Addendum Number Four

To The Drawings and Specifications for **Haysville Activity Center** 523 Sarah Lane Haysville, Kansas 67060

Issued: March 4, 2016

HANNEY & ASSOCIATES ARCHITECTS

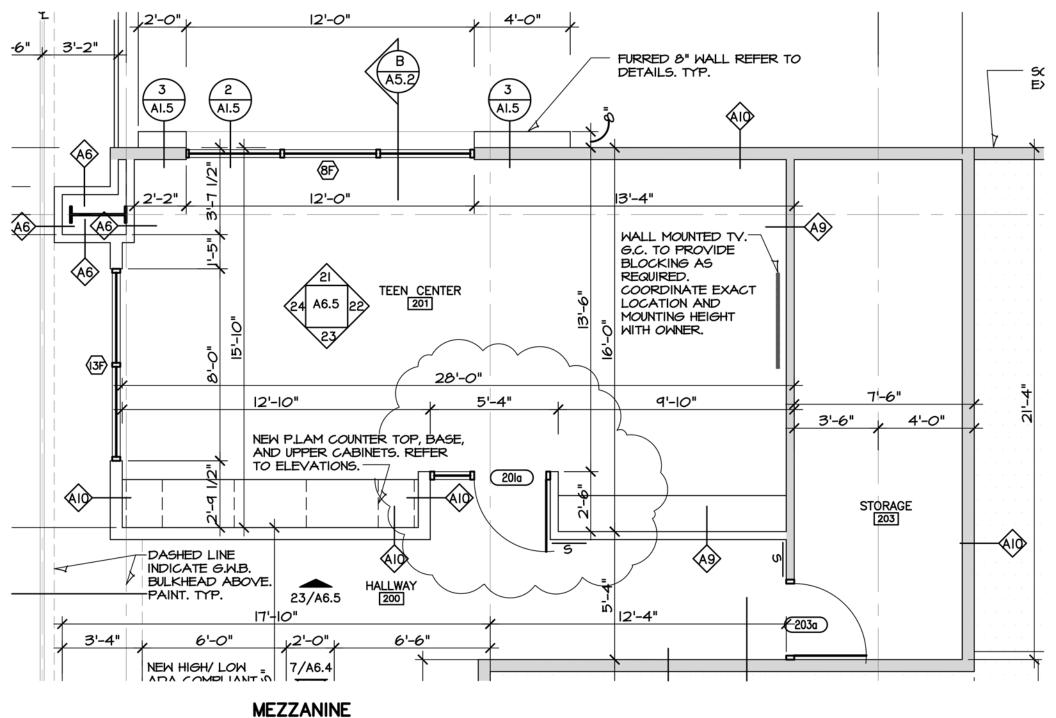
- 3.1 Sheet A1.1 & A3.3
 - 3.1.1 Window Type 9F in classroom 119 as shown on A1.1 and A3.3 has been modified as shown on detail 'C' included in this addendum.

A ENLARGED FLOOR PLAN

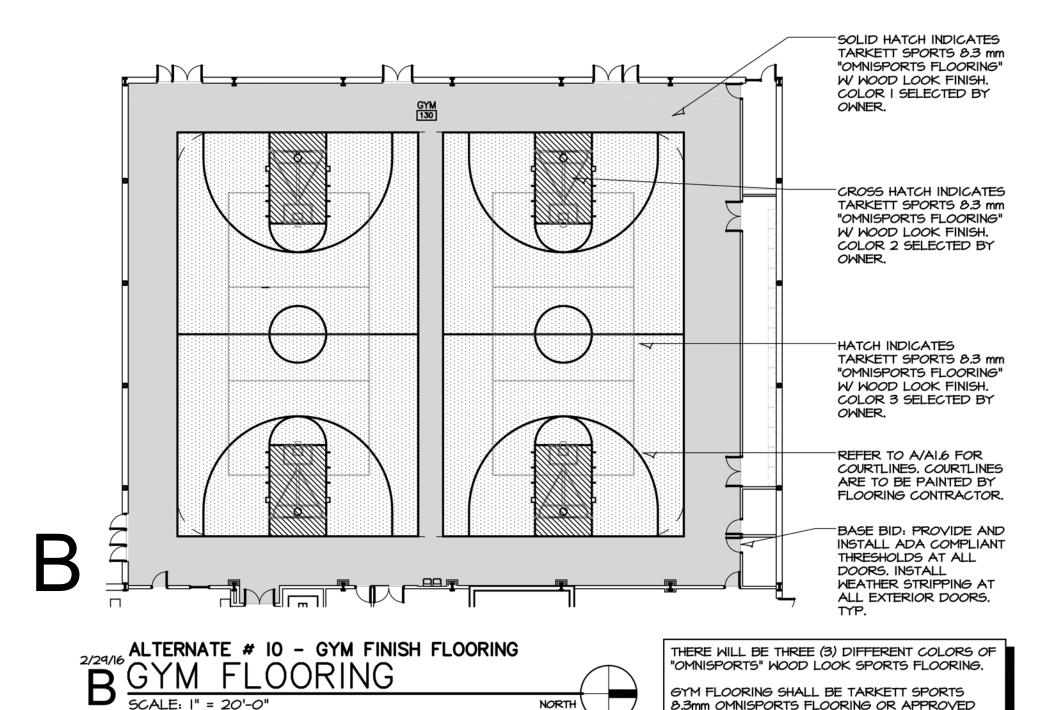
- 3.7 Sheet A1.2, A1.5, & A3.3
 - 3.7.1 Door 201a that has been added into Teen Center (room 200), door assembly to be similar to door type 119a. Door 201a has been added to the door schedule. Refer to attachment "A" included in this addendum.
